# City of Paso Robles Planning Commission Agenda Report

Subject: PD 13-001 Uptown Center – Amendment of Exterior Materials  
3328 Spring St. / APN: 008-042-017, 018, 019 & 020  
Applicant: Rick Jeffery  
Planning Commission to consider a request by Rick Jeffrey on behalf of the Uptown Center project, to amend the Development Plan to omit the requirement that the concrete masonry (CMU) wall be finished with stucco, and allow for the wall to remain with the gray precision block finish.

Date: November 8, 2016

**SITE PLAN**  
 1" = 20'-0" • 24 X 34

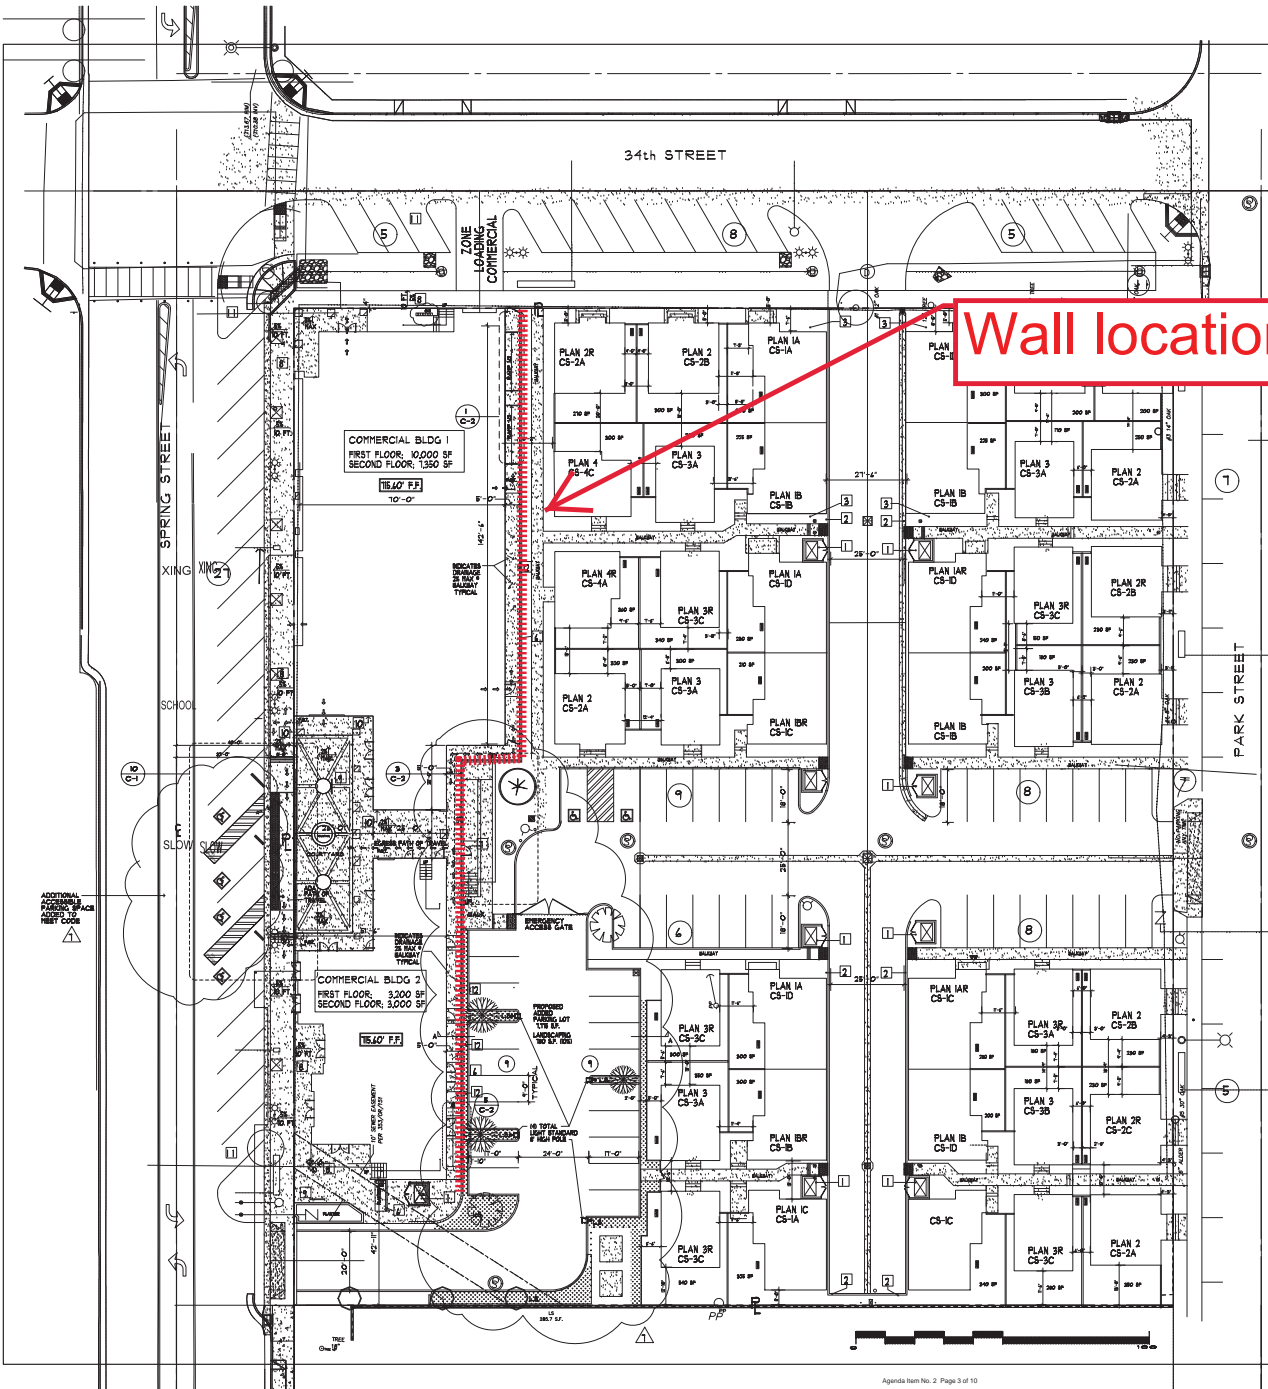
Consider the applicant's request to allow a change from the approved decorative stucco finish to the CMU wall to allow for un-painted precision block.

It is a standard condition that walls be finished in a decorative material as outlined in Standard Condition No. 7, where precision block is not considered an acceptable masonry wall material as being a decorative finish. A precision block wall would introduce a material that is not used in other factors of the project.

When the Development Plan for the Uptown Center was approved, it was approved based on the wall being finished with stucco to correspond with the commercial and residential buildings. The General Plan and Zoning Code has policies that require architectural and design excellence. It has been a standard condition that masonry materials be decorative, where precision block has been specifically excluded as a decorative finish.

Approve Option 1 requiring the wall to be finished in stucco to match the commercial buildings as required by the existing PD.

Exhibit A – Wall Location Plan

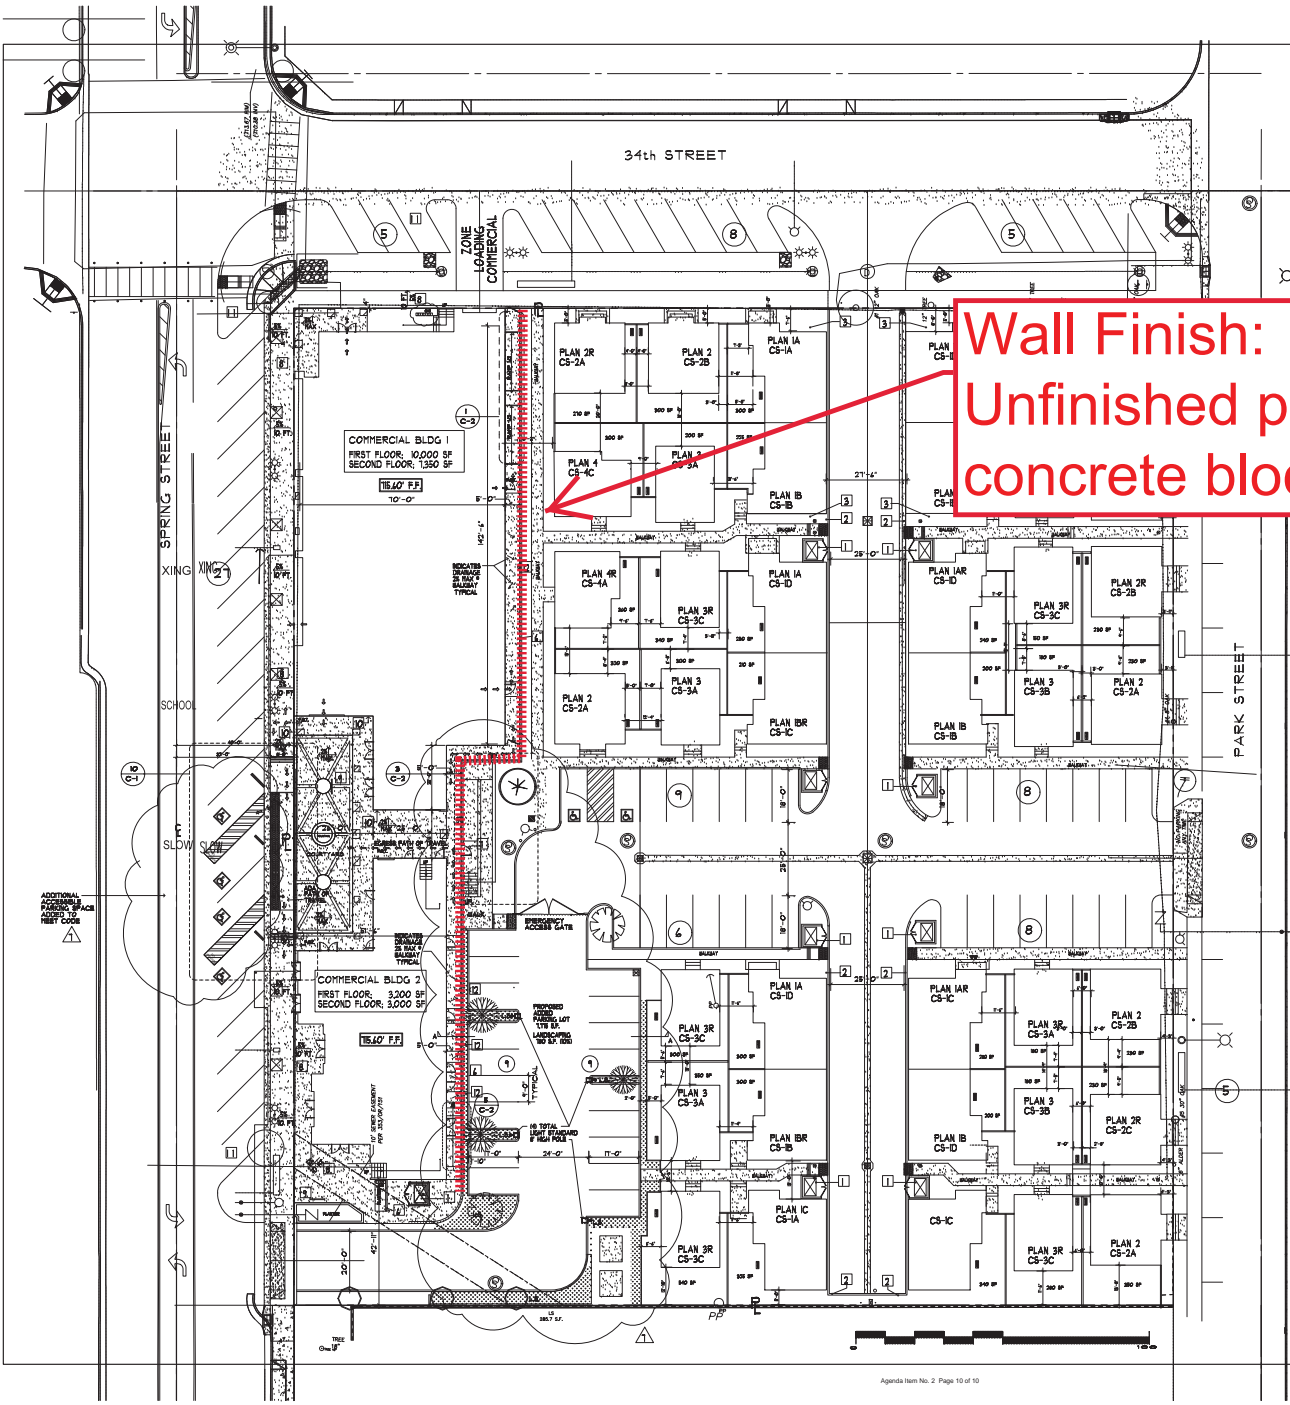
Wall Finish:  
Unfinished precision  
concrete block

The masonry wall located along the back of the commercial buildings may utilize the natural precision block finish material, subject to additional landscaping being provided, including vines that will help screen the wall. The final landscape plan shall be subject to DRC review.
